Parlier HS Stadium Replacement

PBK PROJECT NO.: 250093
DSA FILE NO.: 10-H12
DSA APPLICATION NO.: 02-124002 _ PARLIER HS STADIUM REPLACEMENT

NOTICE TO BIDDERS

END OF ADDENDUM NO. 04

BLDG. N - PLUMBING
PLAN - SEWER, VENT
AND CONDENSATE

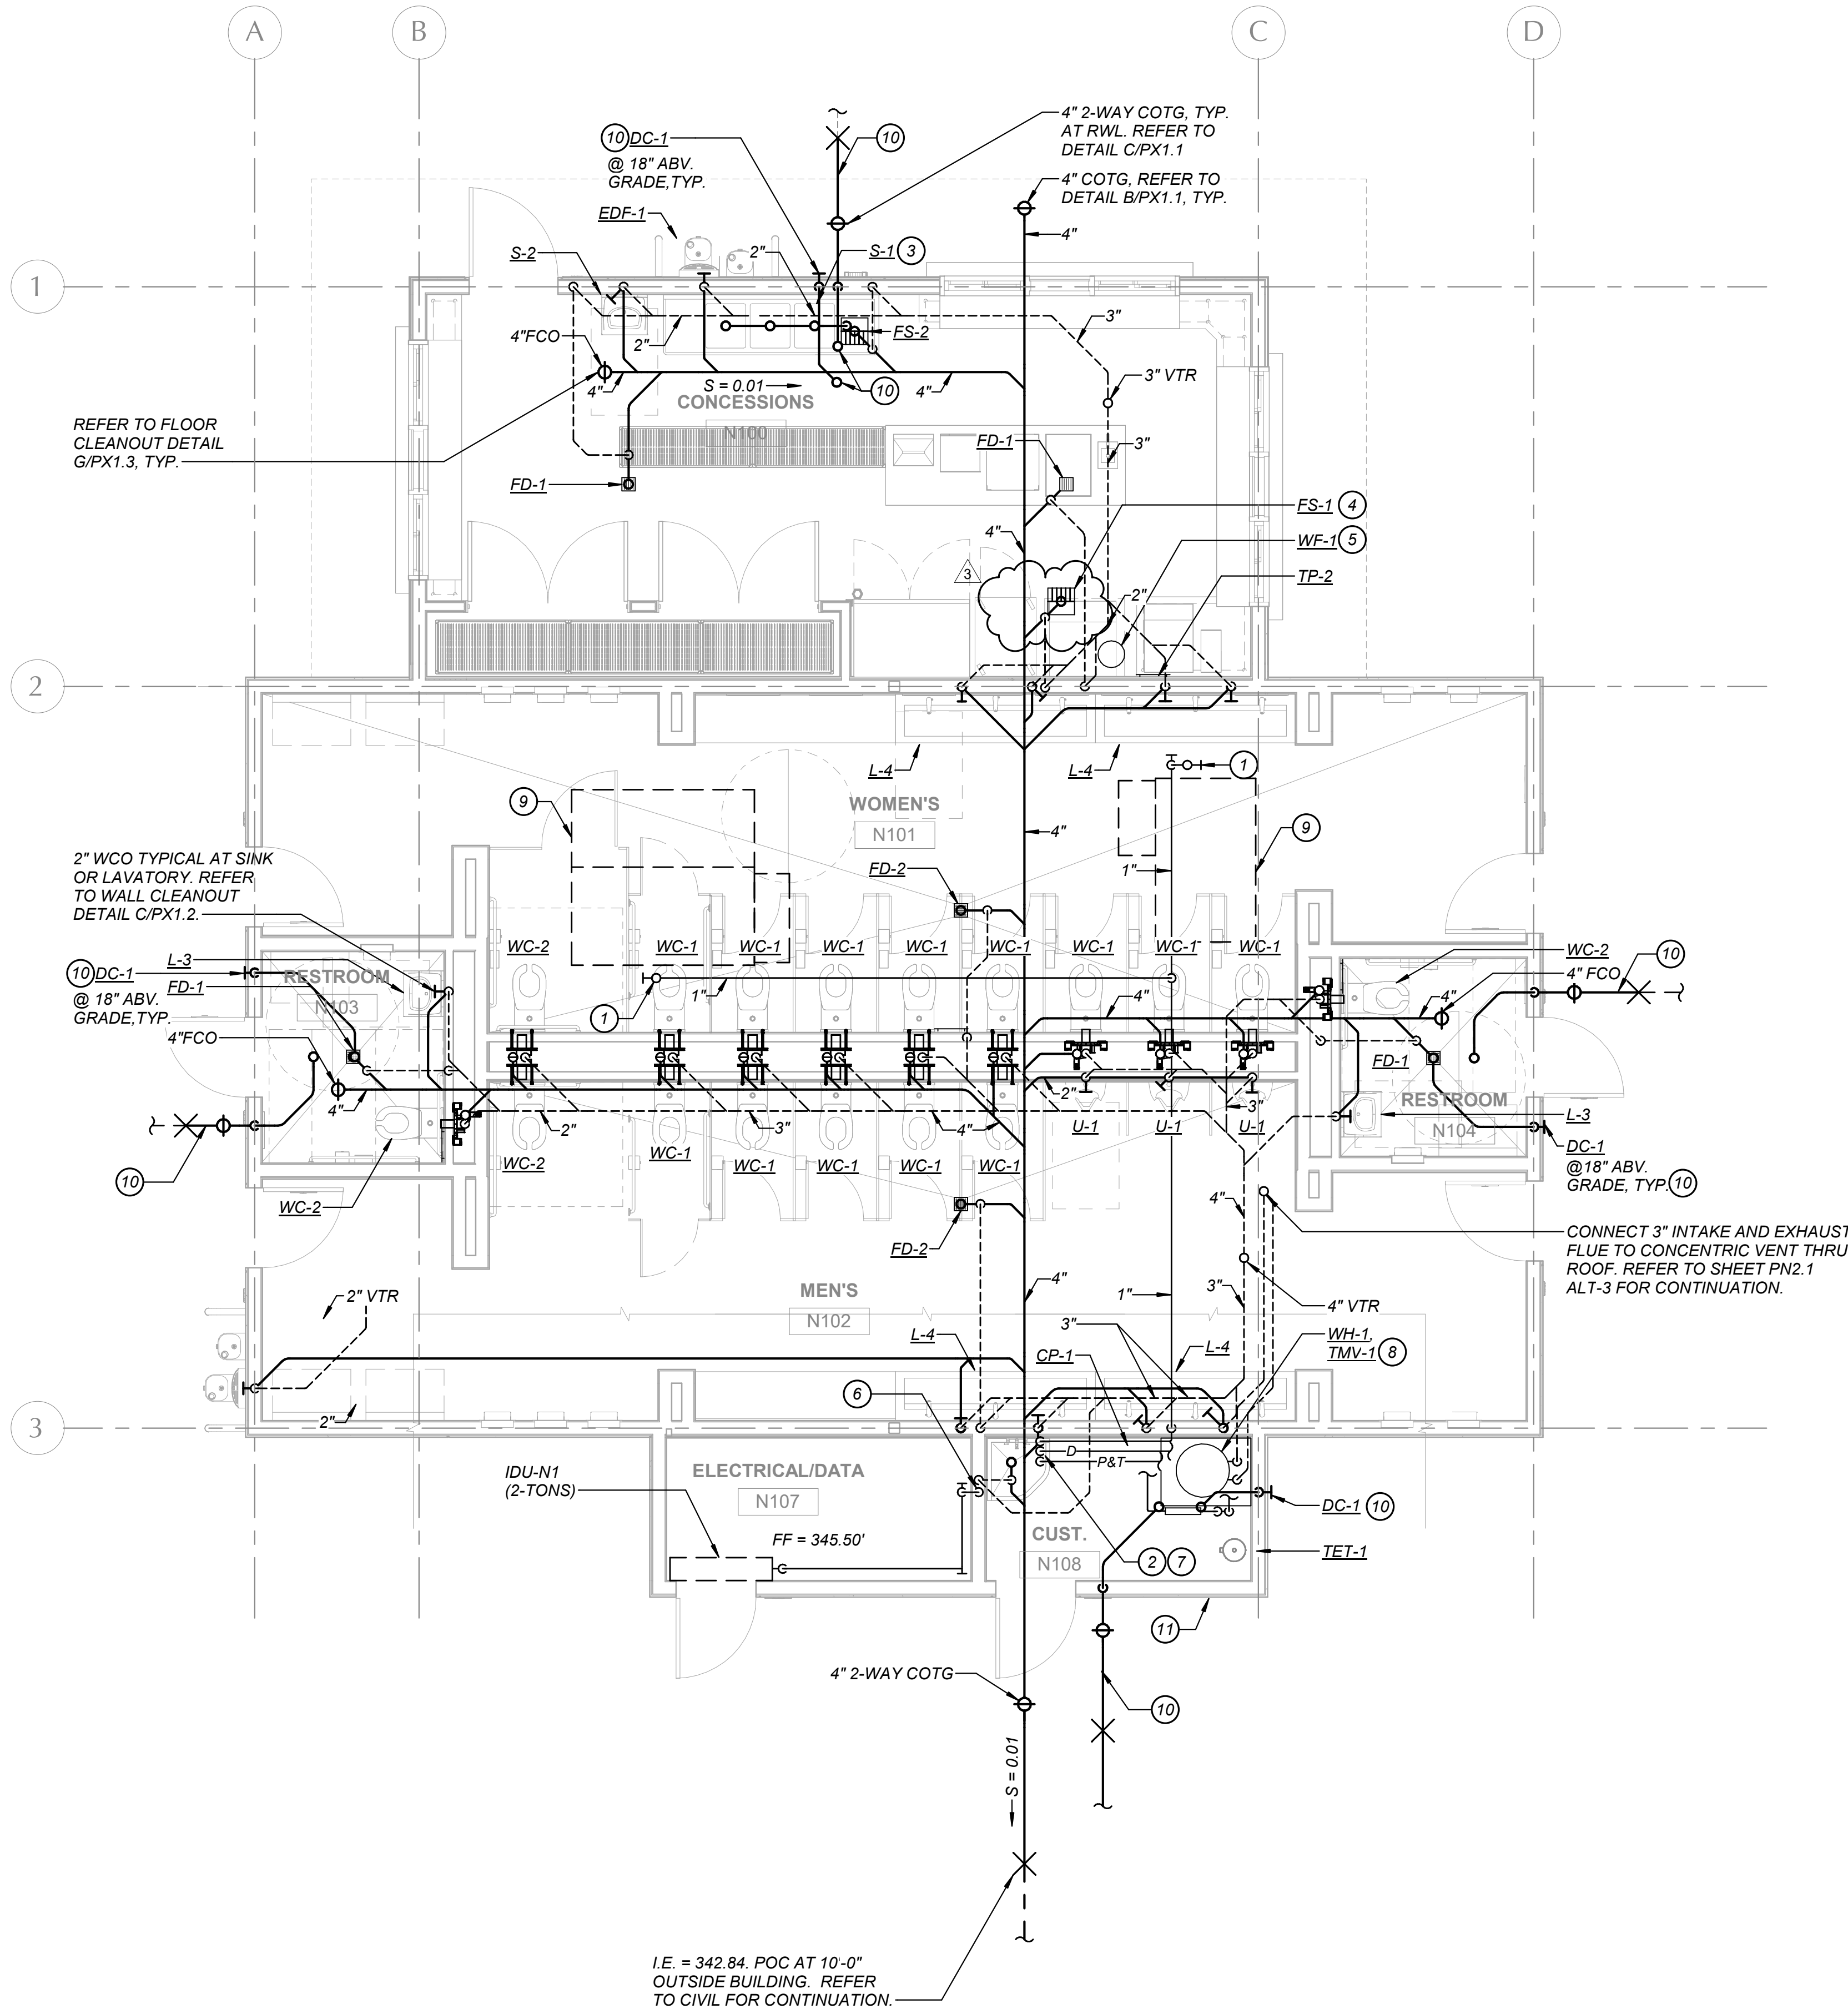
1. Refer to sheet PN1.1 "BLDG. N – PLUBMING PLAN – SEWER, VENT AND CONDENSATE"
 - a. Remove and replace sheet PN1.1 "BLDG. N – PLUBMING PLAN – SEWER, VENT AND CONDENSATE" with herein attached sheet PN1.1 "BLDG. N – PLUBMING PLAN – SEWER, VENT AND CONDENSATE" identified with AD4 on the bottom right-hand corner.

BLDG. N - PLUMBING
PLAN - SEWER, VENT
AND CONDENSATE -
ALT 3

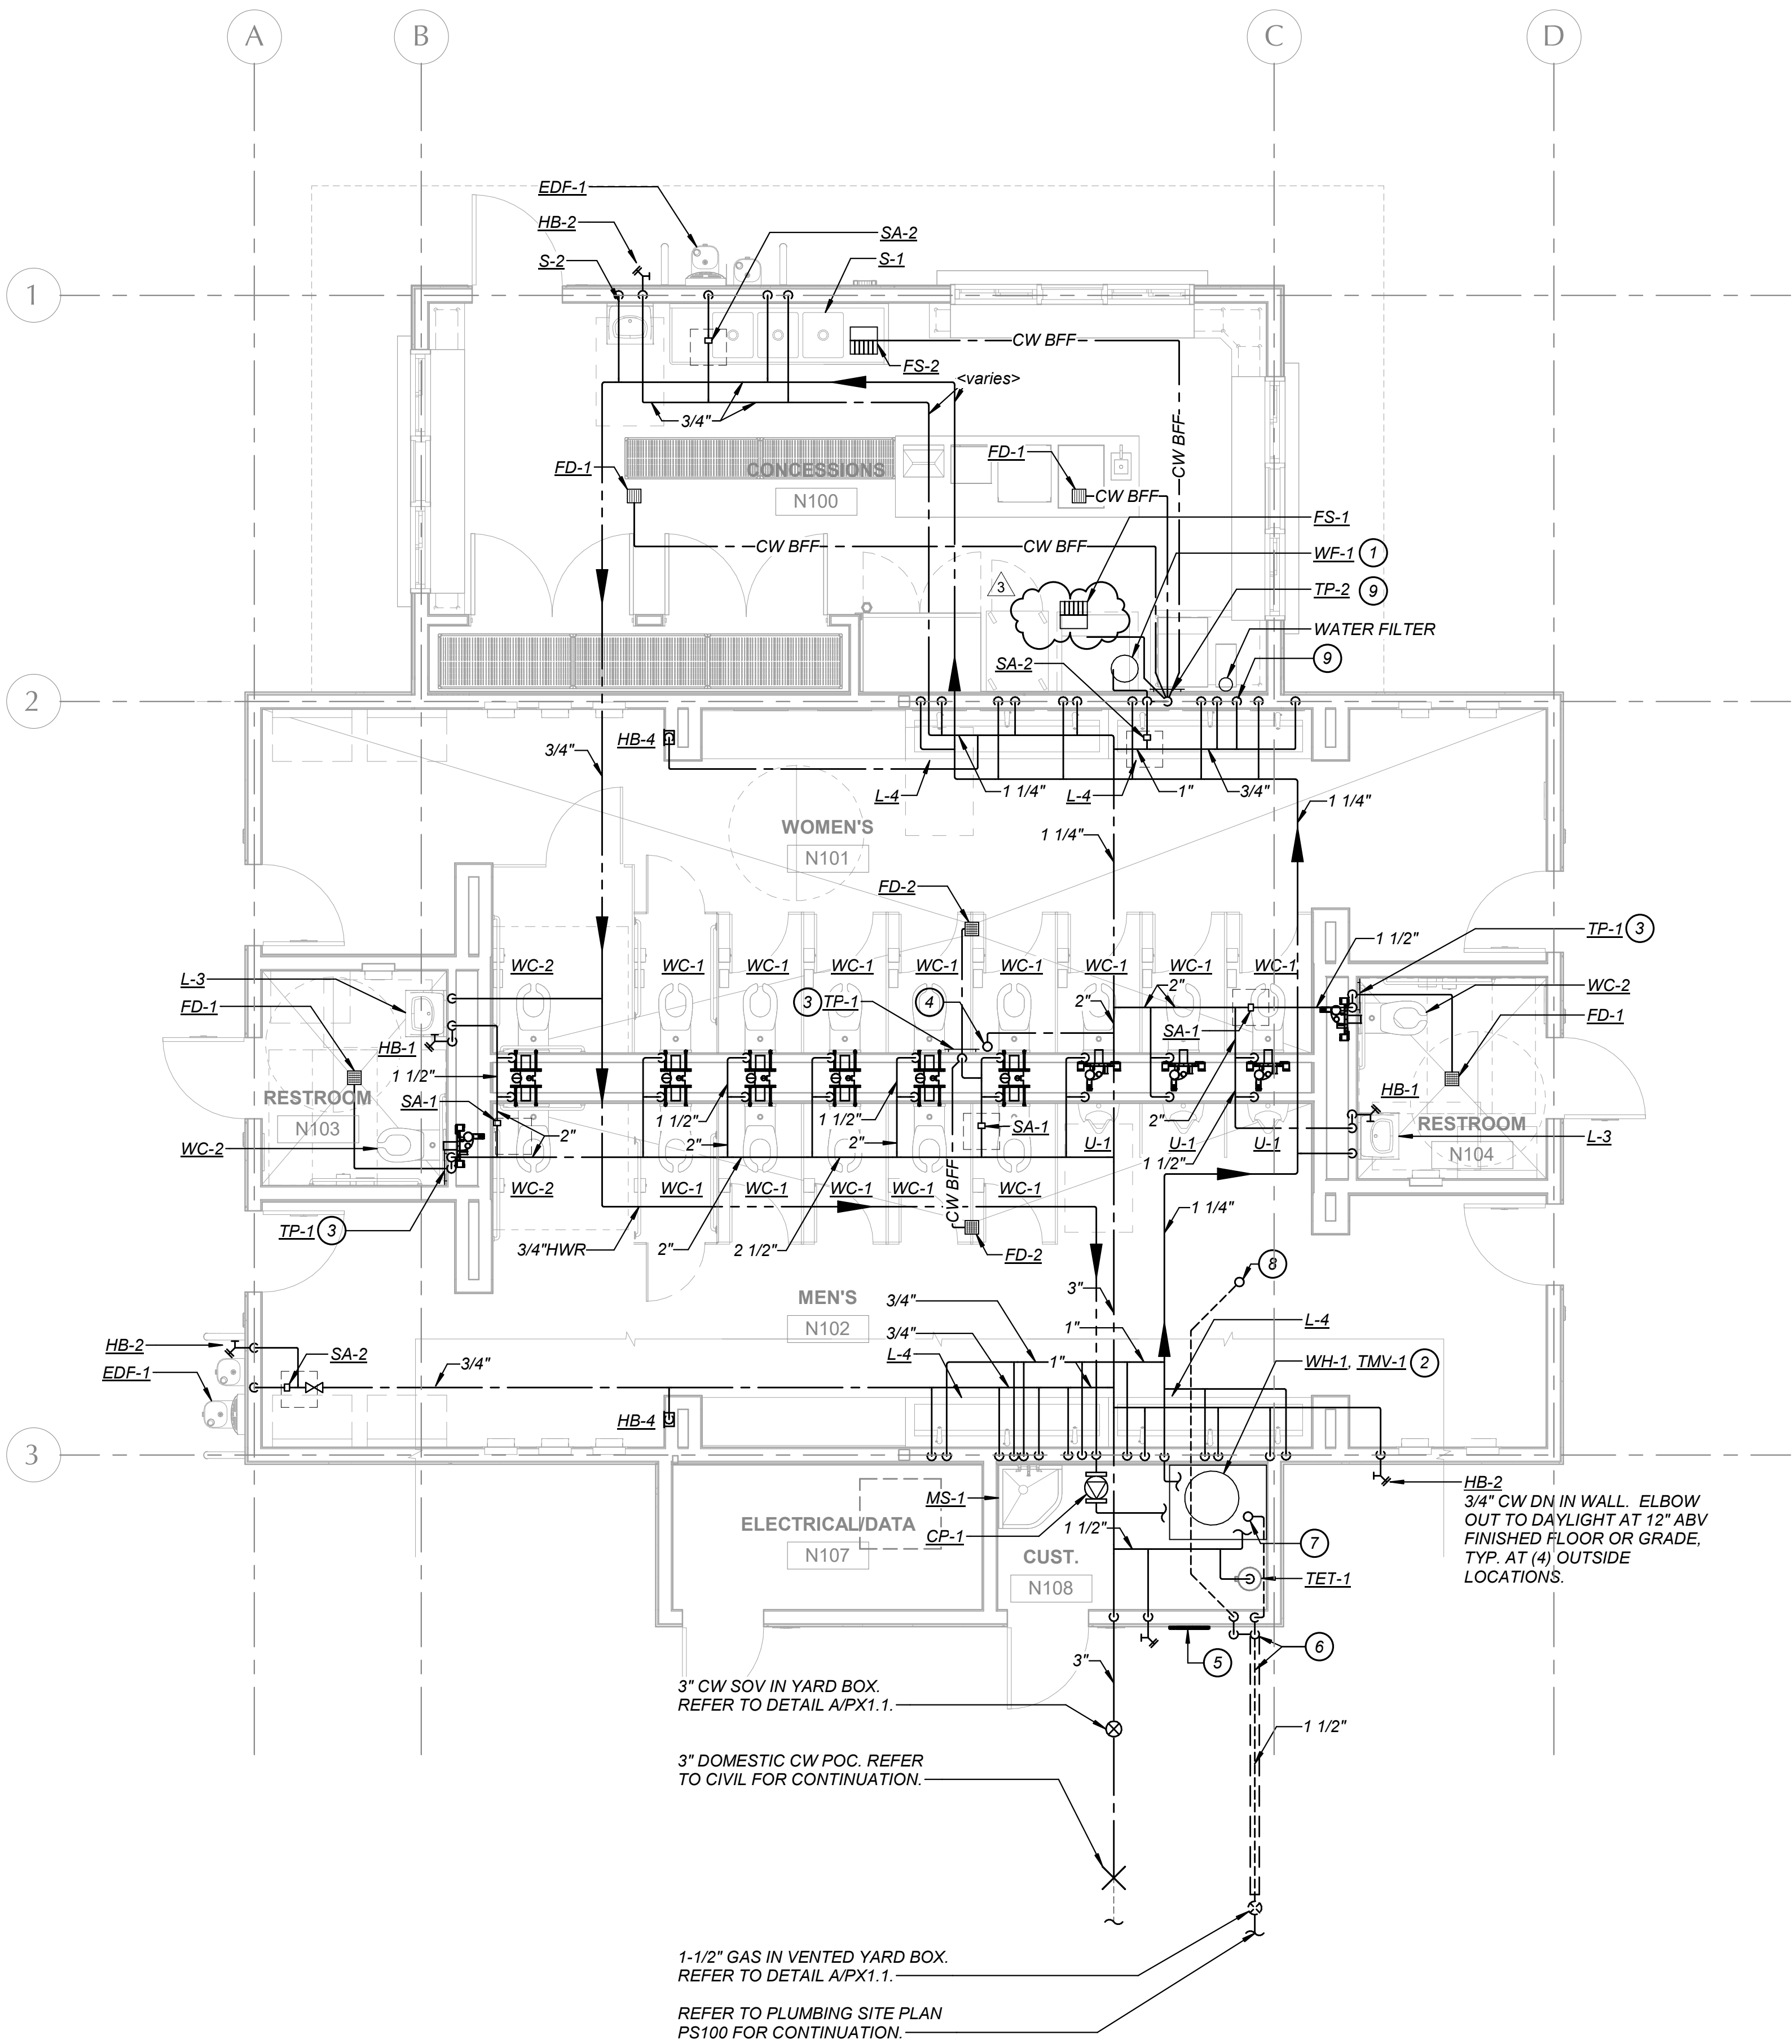
3. Refer to sheet PN1.3 "BLDG. N – PLUBMING PLAN – SEWER, VENT AND CONDENSATE – ALT 3"
 - a. Remove and replace sheet PN1.3 "BLDG. N – PLUBMING PLAN – SEWER, VENT AND CONDENSATE – ALT 3" with herein attached sheet PN1.3 "BLDG. N – PLUBMING PLAN – SEWER, VENT AND CONDENSATE – ALT 3" identified with AD4 on the bottom right-hand corner.
